UNITED STATES
DEPARTMENT OF THE INTERIOR
BUREAU OF LAND MANAGEMENT

FORM APPROVED
OMB NO. 1004-0137
Expires: January 31, 2018**SUNDRY NOTICES AND REPORTS ON WELLS**
*Do not use this form for proposals to drill or to re-enter an abandoned well. Use form 3160-3 (APD) for such proposals.***SUBMIT IN TRIPLICATE - Other Instructions on page 2**

PLEASE SEE PROPOSED P&A PROPOSAL

Well Name: Federal 30 #1 Field: Bell Lake Delaware, North
 Location: SEC 30- 23S-34E; 2080' FNL & 1989' FEL County: Lea State: NM
 Elevation: 3,606' Spud Date: 7/20/90 Compl Date: 4/13/91
 API#: 30-025-30890 Prepared by: Wes Randall Plug Date: Rev: 8/18/16

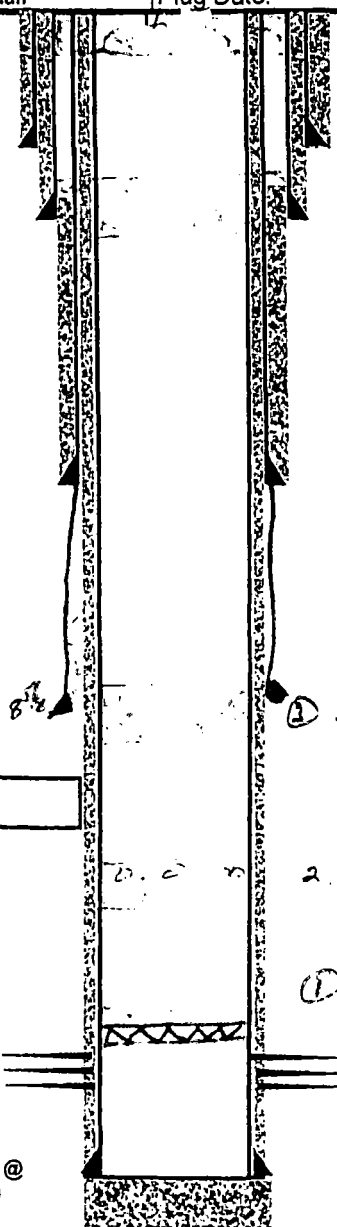
SEE ATTACHED FOR
CONDITIONS OF APPROVALAdd plug 1250. Perf. Sqz cut to 1150
w.c. tag.

5 Perf: Sg2 45' st @ 60' surface

④ Perf: Sg2 45' st @ 650' surface WBC 2 TAs

① Spot 25' st cmt @ 5200-4800 WBC TAs

2. Spot 25' st cmt @ 6600-6400 WBC TAs

① C. 6510 8400 w/ 15' st cmt
